FACILITY: Millstone Nuclear Power Station Unit 2

SUBJECT: SUMMARY OF THE JUNE 11, 1997, MEETING WITH PARSONS POWER GROUP TO DISCUSS THE PROCESS TO BE USED DURING THE TIER 2 ACCIDENT ANALYSIS REVIEW OF THE ICAVP FOR MILLSTONE UNIT 2

## Review of Main Steam Line Break at HZP with Offsite Power Available

FIGURE 14.15-1 ONE PUMP HIGH PRESSURE SAFETY INJECTION  
SYSTEM DELIVERY VS. PRIMARY PRESSURE

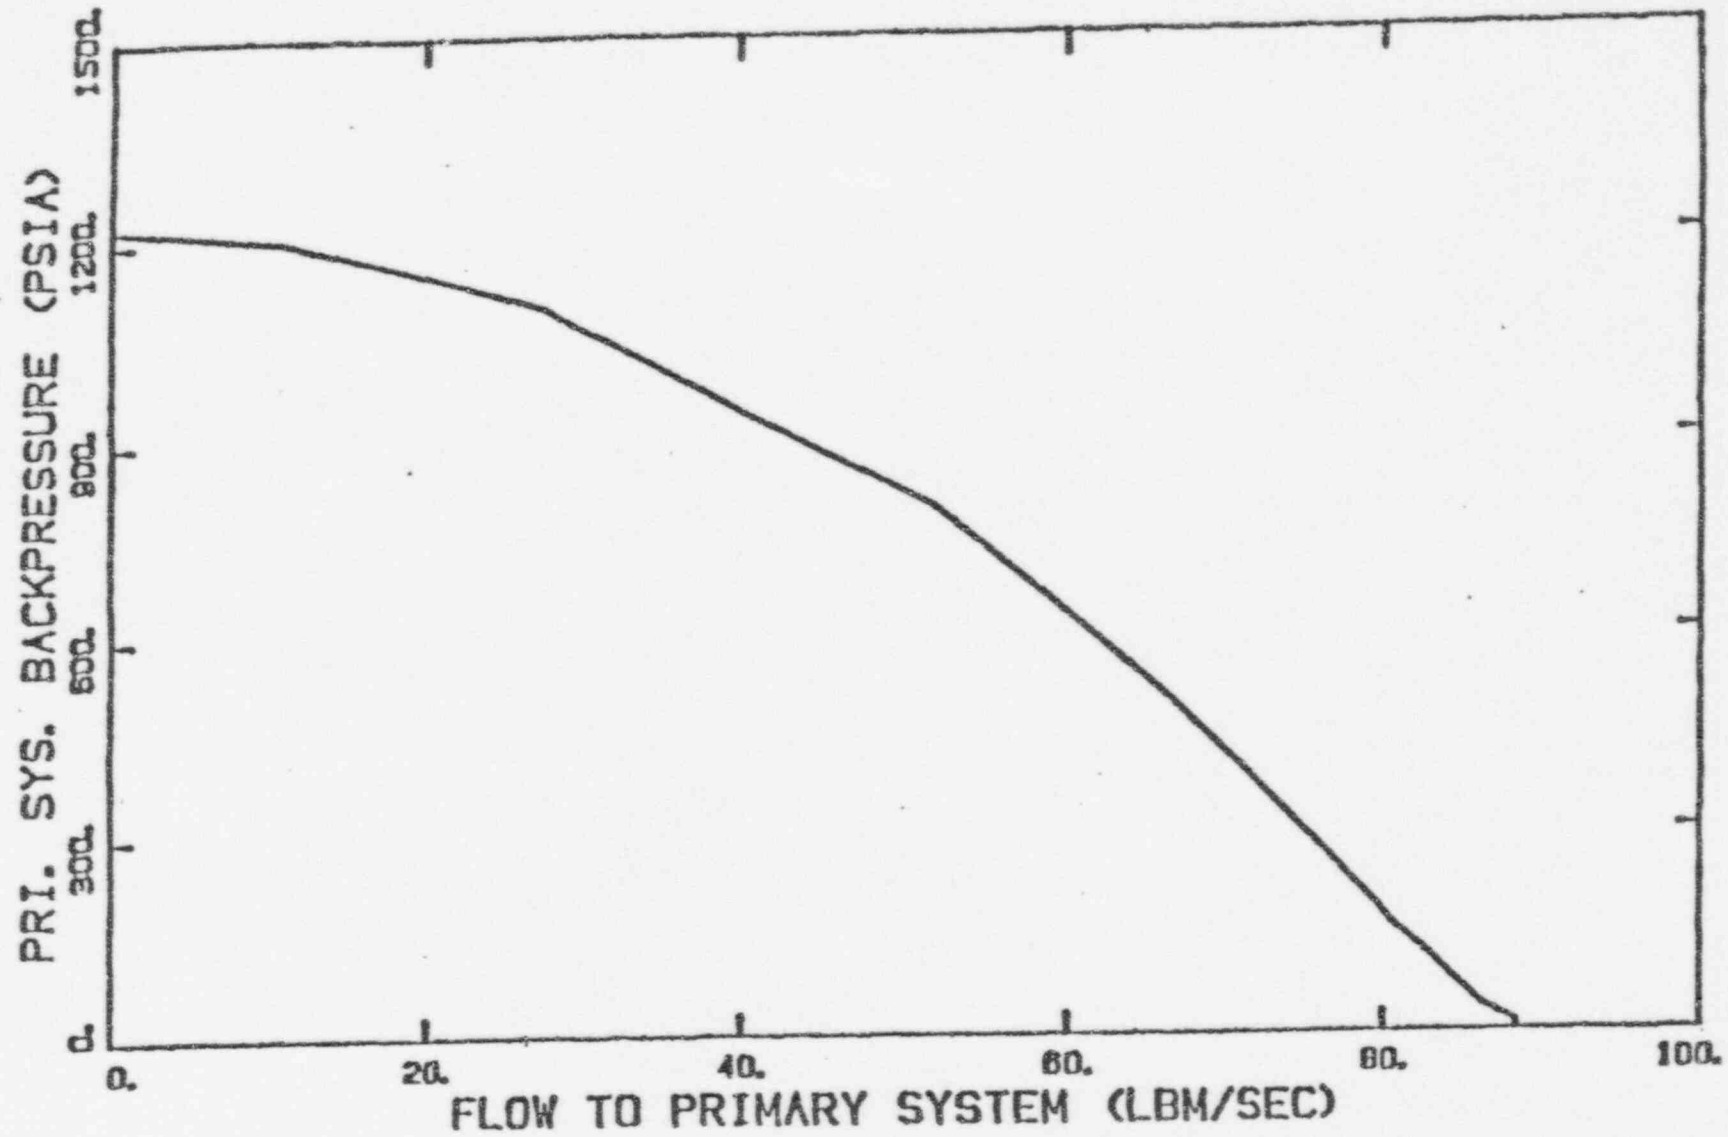
**HPSI Pump Performance** - Provided as Figure 14.1.5-1, HPSI flow vs. RCS backpressure curve.

Reference: FSAR Section 14.1.5.5.1.2, Figure 14.1.5-1.

Validation: Compare to plant ISI procedure acceptance criteria.
